Nebraska Public Power District

NLS2007012
April 17, 2007

Subject: Response to Request for Additional Information Regarding License Amendment Request for Onsite Spent Fuel Storage Expansion
Cooper Nuclear Station, Docket No. 50-298, DPR-46

**Response to Health Physics Branch Request for Additional Information Regarding
License Amendment Request for Spent Fuel Pool Storage Expansion**

Figure 1

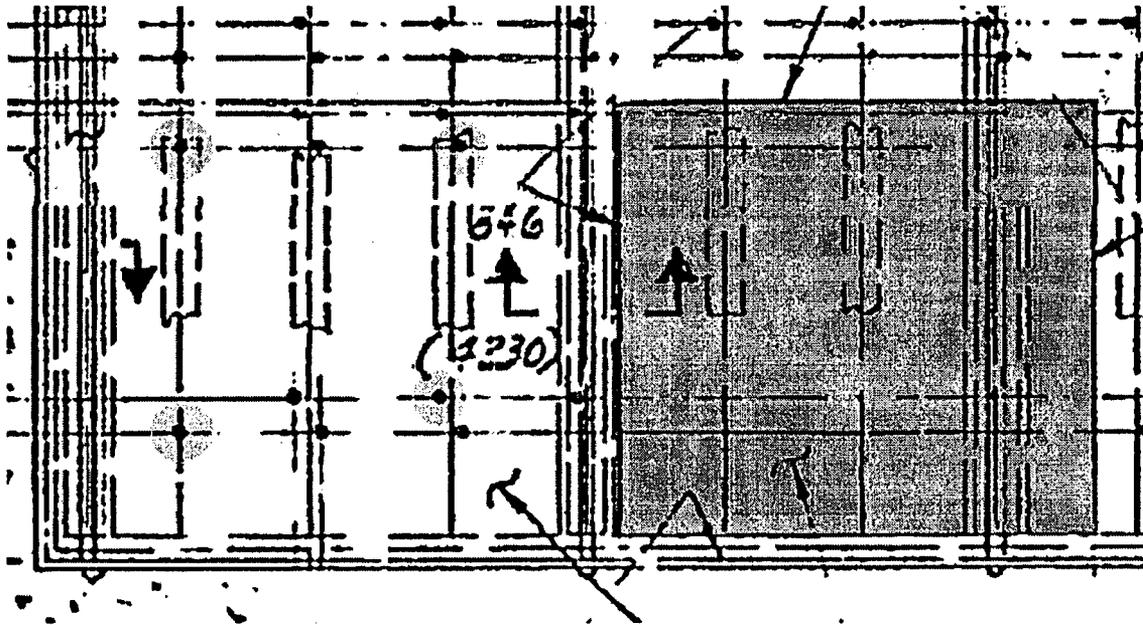
Please provide a summary of the stress analysis of the swing bolts and swing bolt anchorages to the pool slab for the loads transmitted by the Rack A fuel rack and platform. Please provide a drawing showing the anchorage pattern.

Burns and Roe drawings Number 4228, Rev. 11, and Number 4230, Rev. 14, are provided as part of this response. The locations of the hold-down bolts are shown on Drawing No. 4228, in the section labeled Plan – Fuel Storage Pool @ El. 962'3". The dashed lines running East-to-West (North is shown on the drawing) show the location of the embedded "W" sections to which the ¼-inch stainless steel (SS) liner plate pieces were welded. The small dots on these lines depict the location of the hold-down bolts ("swing-bolts") which were welded directly to the same embedded "W" sections, and to the ¼-inch SS liner plates. The anchorage pattern is shown in Figure 1.

Drawing No. 4230, Sections 859-859 and 860-860, shows the details of the welded connection between the swing-bolt clevis and the embedded "W" section/liner plate. The connection of the "W" sections to the cast-in-place anchors is shown in Section 846-846.

This figure is an excerpt from the structural detail information (section labeled *Plan - Fuel Storage Pool @ EL. 962'-3"*) provided on Burns and Roe Drawing 4228. The anchorage pattern of the four (4) "swing-bolts" utilized to secure the platform for new Rack A is shown by the light grey shading. For reference purposes, the shaded area is the existing pool-floor cask bearing pad (1-inch plate).

Figure 2
Rack A Platform Finite Element Model

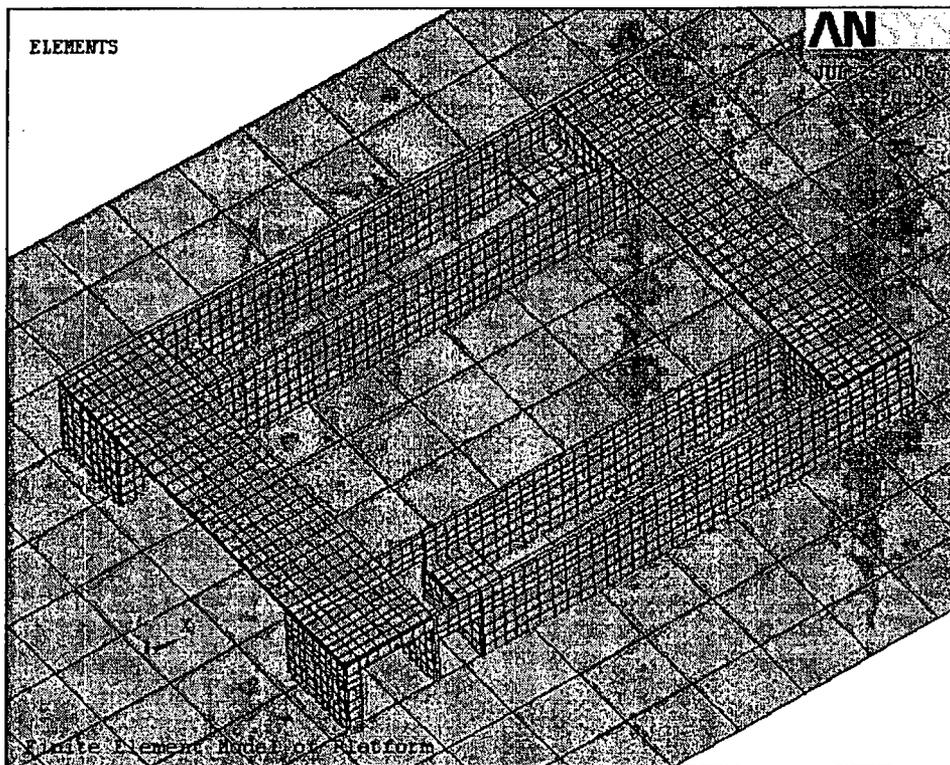
Please provide a summary of the stress analyses for the Rack A and B platforms. Please provide the drawings for the platforms.

A stress analysis of the Rack A platform has been performed using the finite element code ANSYS. The model, which is comprised of 4-noded shell elements, is shown in Figure 2. The finite element model is fixed at the base since the Rack A platform is restrained against lateral motion through its connection to four existing swing bolts on the SFP floor. Each of the swing bolts is preloaded to 10,000 lbs when the platform is installed to increase the frictional resistance at the SFP liner/platform interface. The maximum pedestal loads (in the horizontal and vertical directions) from the rack dynamic analysis are applied to the top surface of the Rack A platform model as nodal forces. Stresses in the platform components and welds are shown to meet ASME, Section III, Subsection NF and Appendix F for Level A and Level D service loadings, respectively. The minimum safety factors for the Rack A platform are summarized in the following table.

Platform and Components		Safety Factor	
		Level A (OBE)	Level D (SSE)
Platform	Membrane	1.24	1.07
	Membrane plus Bending	1.84	1.18
	Bearing	26.0	N/A
Welds	Bracket	10.5	4.05
	Mainframe Panel	2.79	2.75
	Top Pad	1.63	1.74
	Swing Bolt Hold Down Plate	1.64	N/A

Figure 3
SSE Response Spectra for Vertical Ground Motion
(Note: Vertical ground motion is derived by applying a factor of 2/3 to the above spectrum)

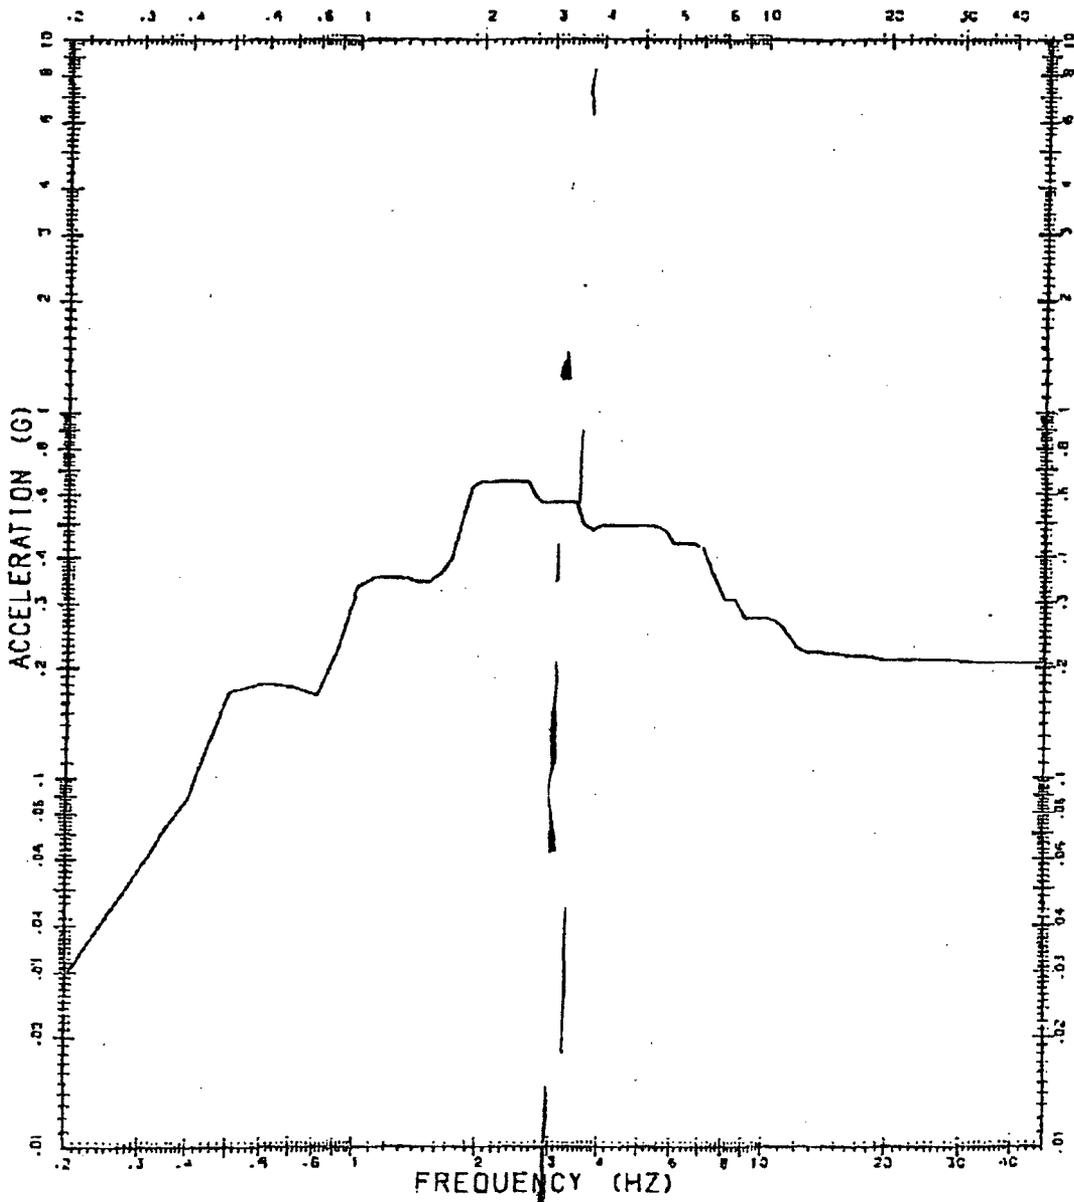
Table 6.7.1 of the Holtec report specifies 4 percent damping for Operating Basis Earthquake (OBE) and 5 percent damping for Safe Shutdown Earthquake (SSE) as input data for the rack seismic analysis. Table 1 of NRC Regulatory Guide 1.61 specifies 2 percent damping for OBE and 4 percent damping for SSE for welded steel structures. Please discuss the appropriateness of the damping values used in the analysis.

The subject CNS OBE floor response spectra (at 4 percent damping) and SSE floor response spectra (at 5 percent damping), were not directly utilized to conduct dynamic response spectra-type analyses of the proposed new storage racks. The subject floor response spectra for the 976’-0” elevation of the Reactor Building were utilized to create artificial acceleration time histories of the dynamic input motion applicable to the location of the proposed fuel storage racks. The synthetic “conversion” of the subject floor response spectra information to artificial time-history input motion was confirmed to be accurate by ensuring that “output” floor response spectra, created from these artificial time-history input motions, would adequately and appropriately envelope the CNS OBE and SSE floor response spectra originally provided to the analysts. These “verified” artificial time histories were then used as input data to conduct the non-linear dynamic analyses of the new storage racks, which are base-supported on the storage pool floor, elevation 962’-3.”

As the lowest fundamental mode of horizontal structural response in the proposed new storage racks was determined by analysis to be approximately 7 Hz, and because the input dynamic response was applicable to an elevation higher than the pool floor (976’-0” versus 962’-3”), the effect of this non-conservative assumption is not significant.

Seismic Level	7 Hz Response at 1% Damping, 958’-3”/ 976’-0” Level	7 Hz Response at 4% Damping, 976’-0” Level	7 Hz Response at 5% Damping, 976’-0” Level	Potential Impact of 1% Damping on Response
OBE	0.37g	0.37g	N/A	Nil
SSE	0.60g	N/A	0.58g	0.02 g (3.3%) increase
